**May 24, 2019**  
**BOARD OF COUNTY COMMISSIONERS**  
**ORANGE COUNTY, FLORIDA**  
**Y19-758-RM / Addendum No. 1**  
**OAKVIEW DRIVE DRAINAGE IMPROVEMENTS PROJECT**  
**THE REVISED OPENING DATE IS JUNE 20, 2019**

**PLAN & PROFILE**

SHEET  
**11**  
 SAI  
 Job No.  
 2017-017.10

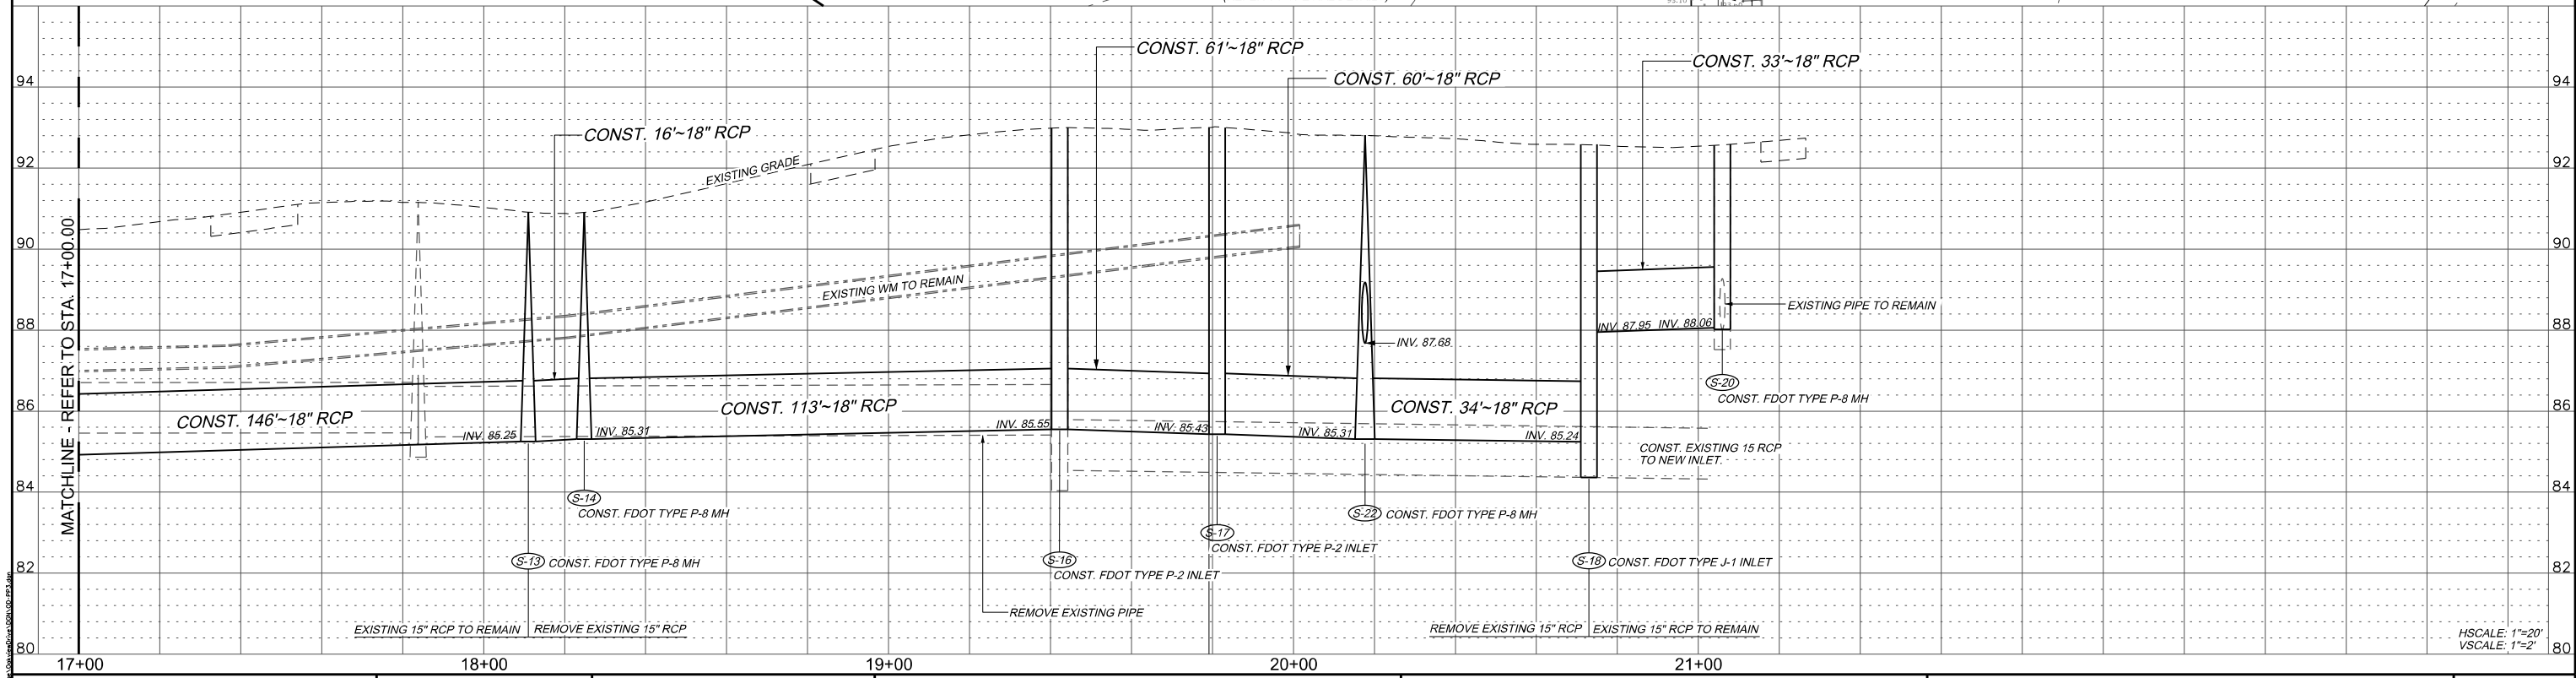
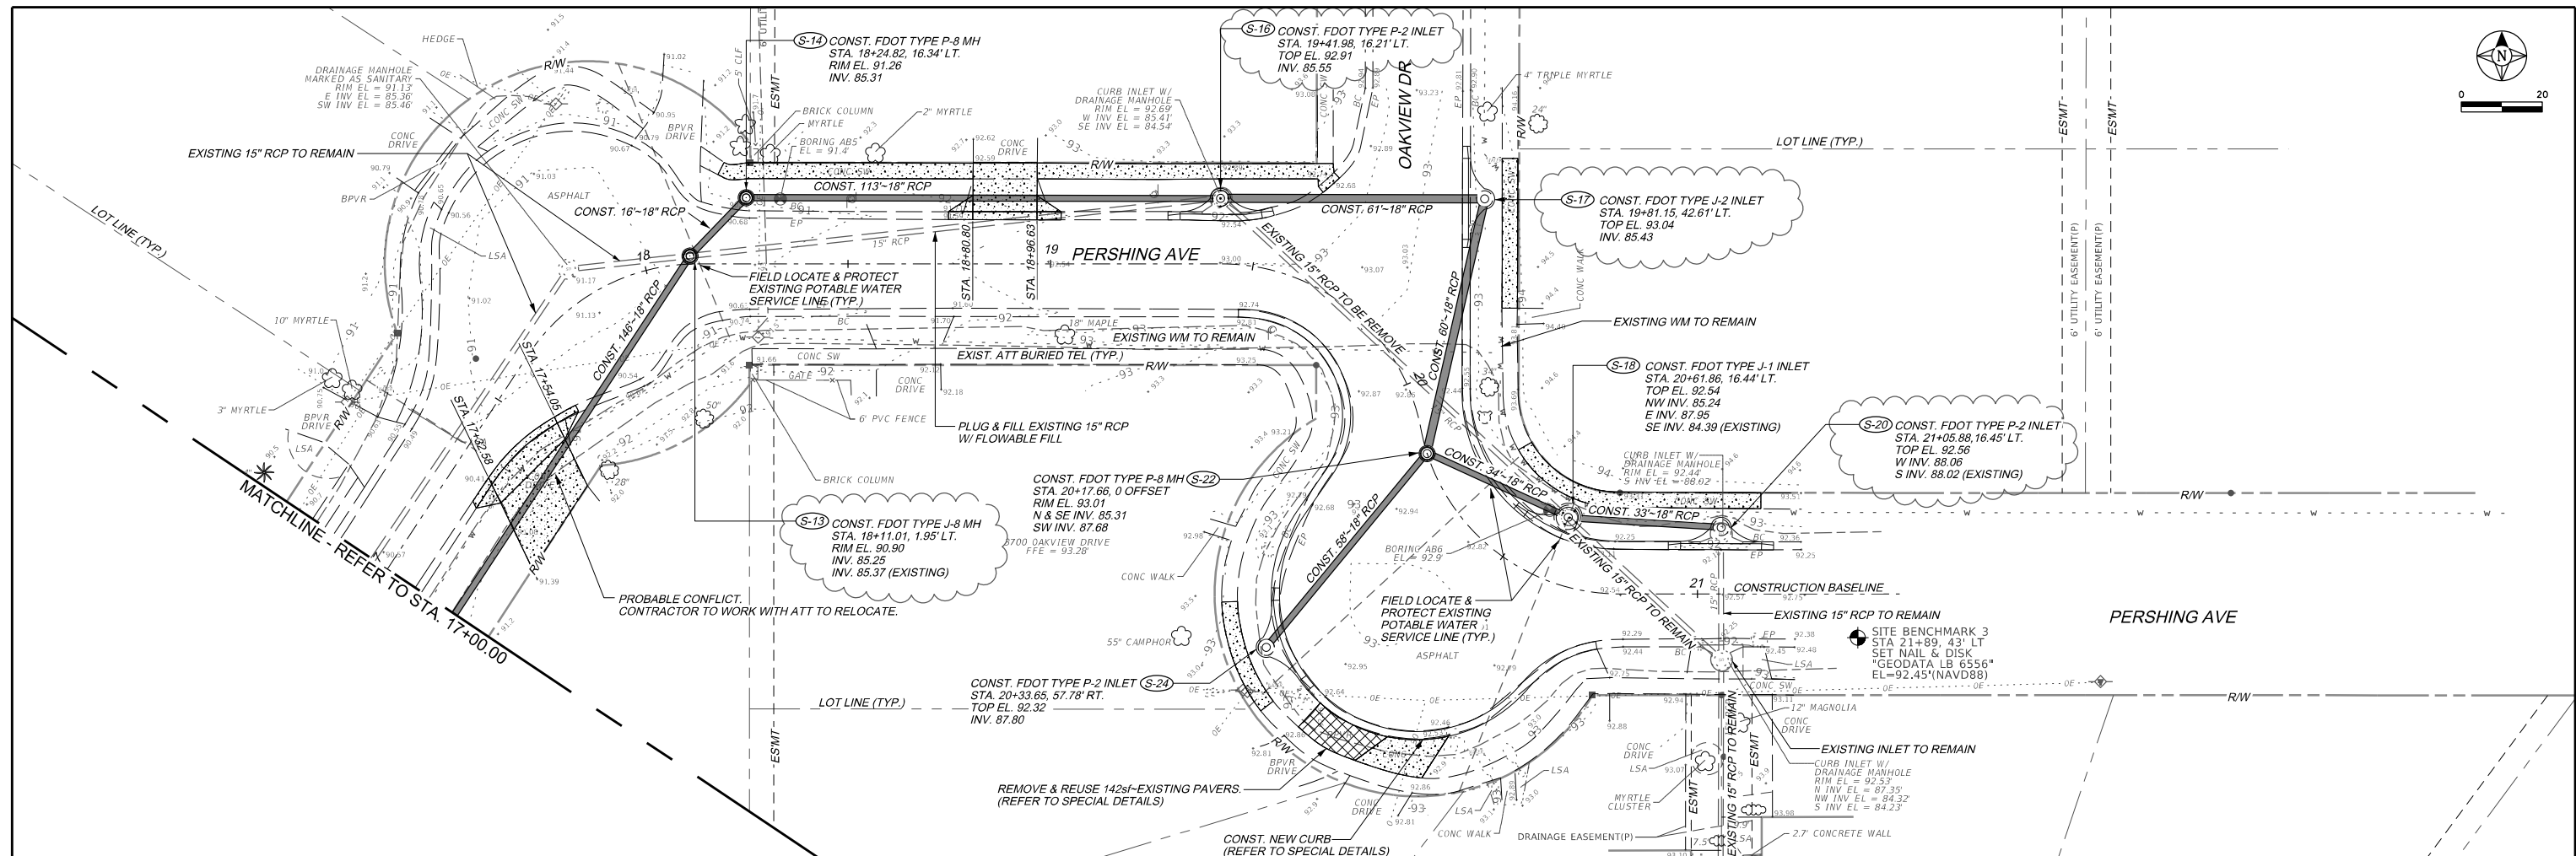
**3. Question:** On Sheet 11, Structure S-20 is labeled as a P-8 MH, but is show as an inlet, please clarify

**Response:** Structure S-20 is an FDOT TYPE P-2 INLET, The Bid Form is correct. Please see attached revised sheet 11.

SHEET  
**10**  
 SAI  
 Job No.  
 2017-017.10

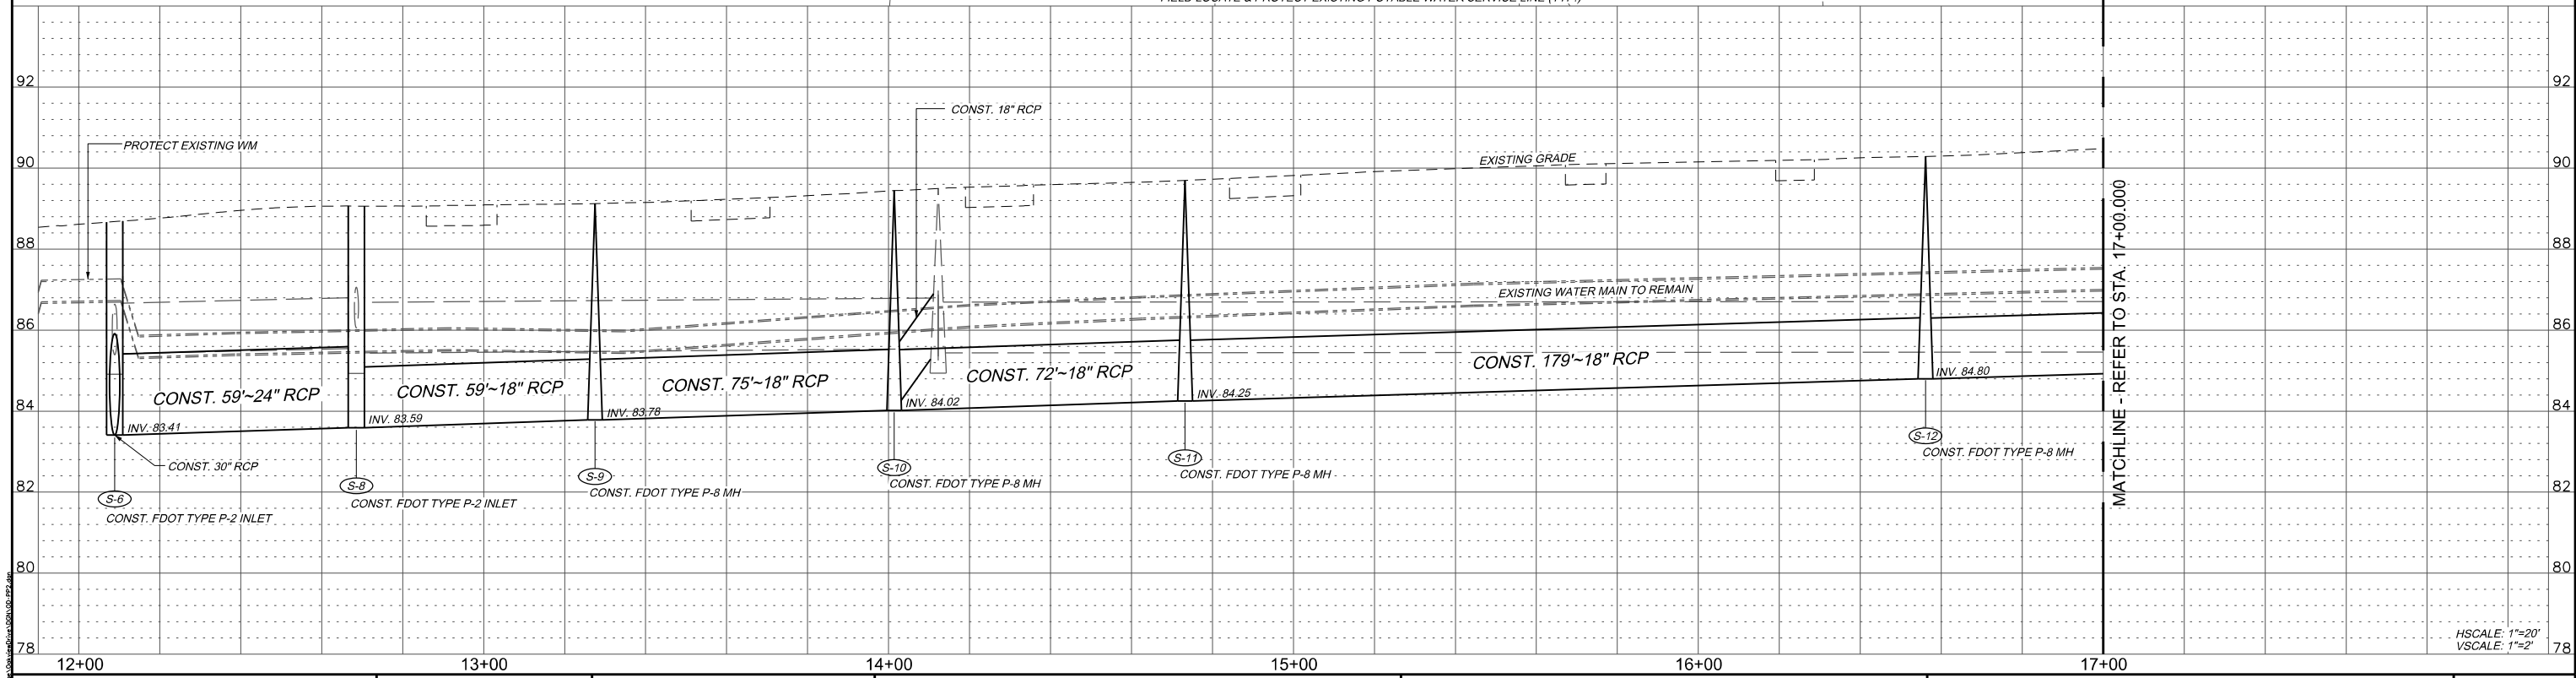
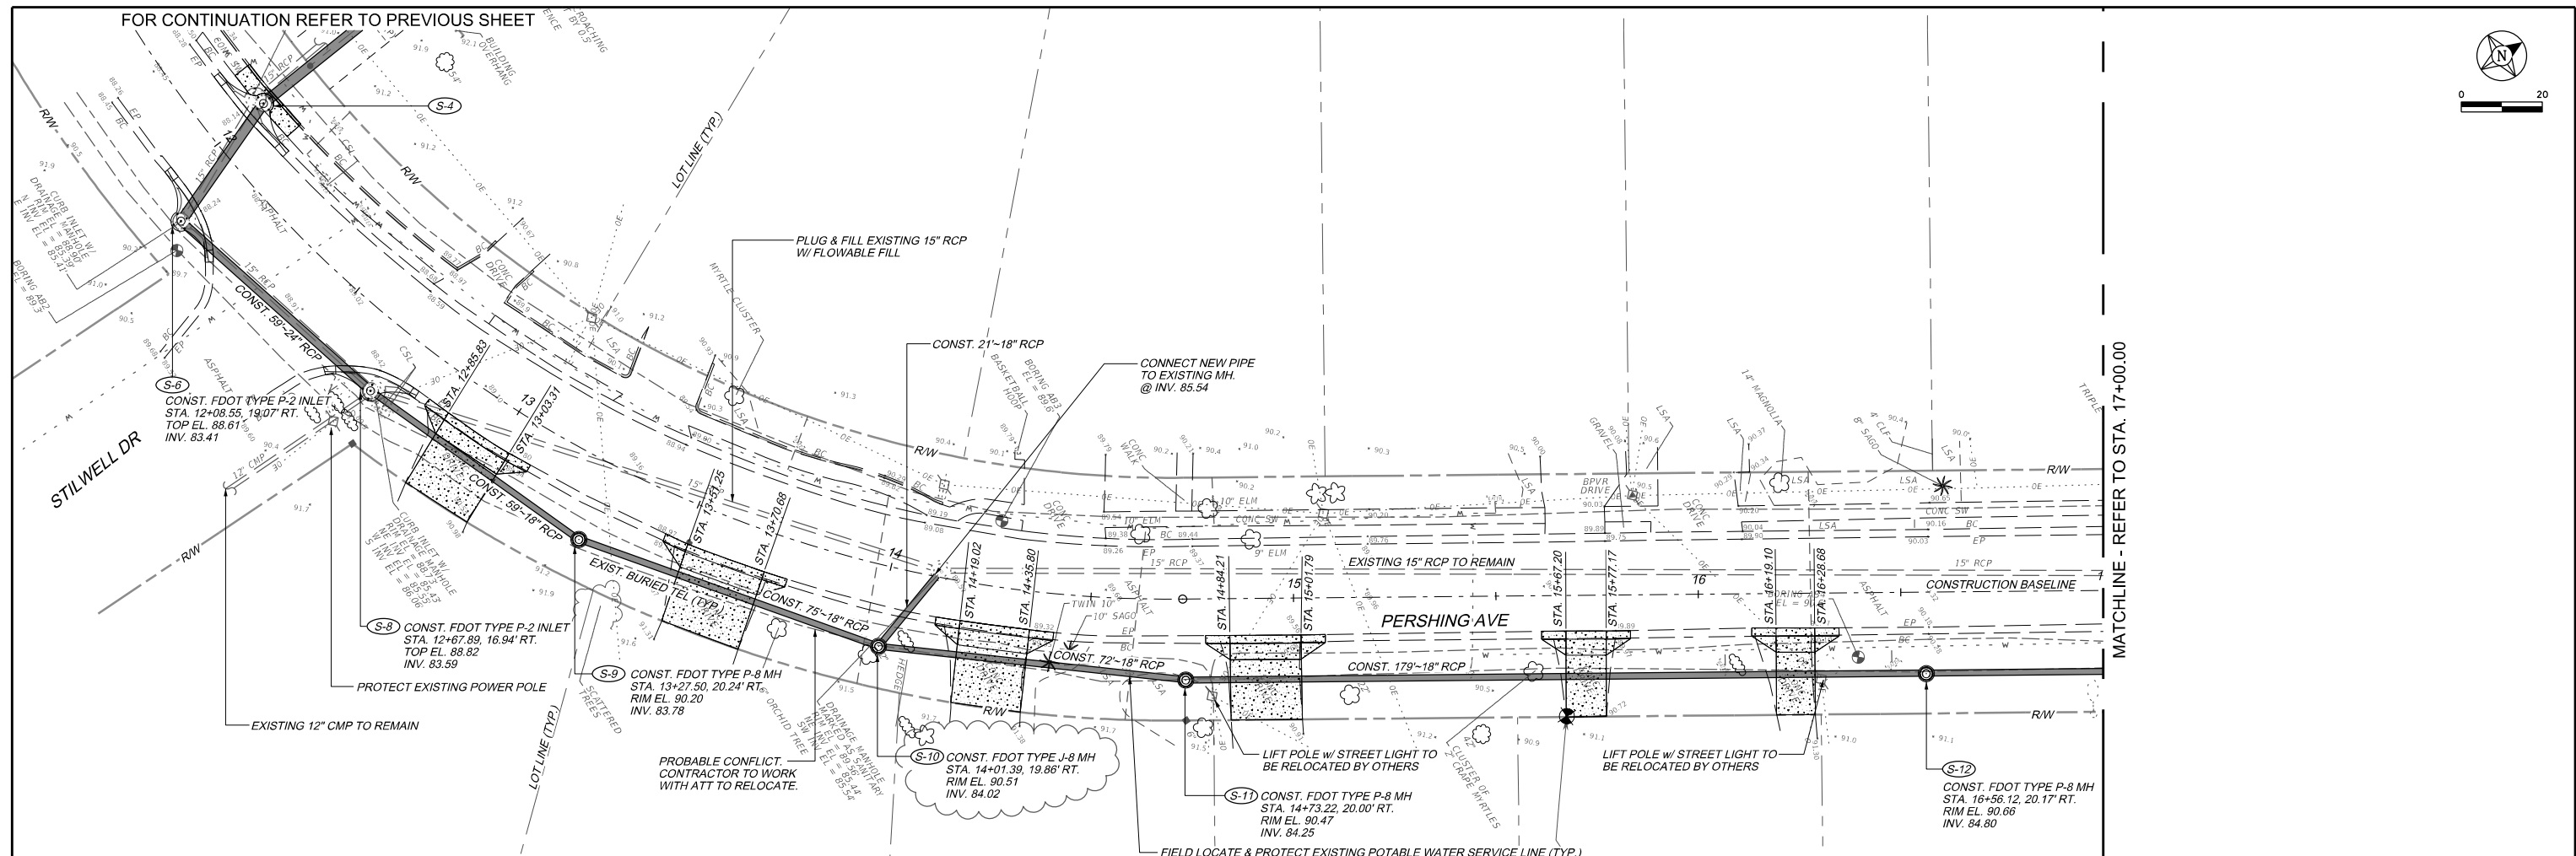
**5. Question:** Bid Item 5 calls for Flowable Fill, is this Bid Item referring to the Road Patch Detail show on Sheet 3 "Typical RCP Installation and Trench Backfill" or is this Bid Item for the abandon of the Existing 15" RCP In Two Locations. TP121 does not specify, please clarify scope of pay item for Bid Item 5.

**Response:** The quantity for Flowable Fill is for the pipe callouts on sheets 10 and 11 Sta. 12+70 to 14+10 & Sta. 18+11 to 19+40. Please see attached revised sheet 10.
